This Service Information bulletin supersedes SI 34 03 14 **dated May 2014**.

Service Action: Program Control Units (Dynamic Stability Control [DSC] OBD error)

F15 (X5)

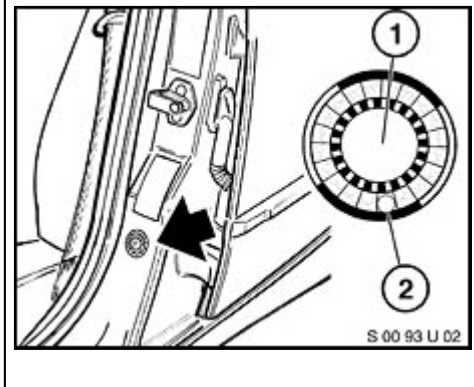
NEW Note: If loss of communication with the DSC module occurs during vehicle programming, it may be possible to restore communication by using the following workaround procedure:

1. Disconnect the DSC control module from the power supply (remove the DSC module connector).
2. Disconnect the battery charger and battery.
3. Wait at least 5 minutes.
4. Reconnect the DSC control module.
5. Connect the battery and charger.

NEW It should now be possible to diagnose the DSC control module again. A new programming session can now be performed.

NEW In some cases, this will not be successful and a replacement DSC module is required.
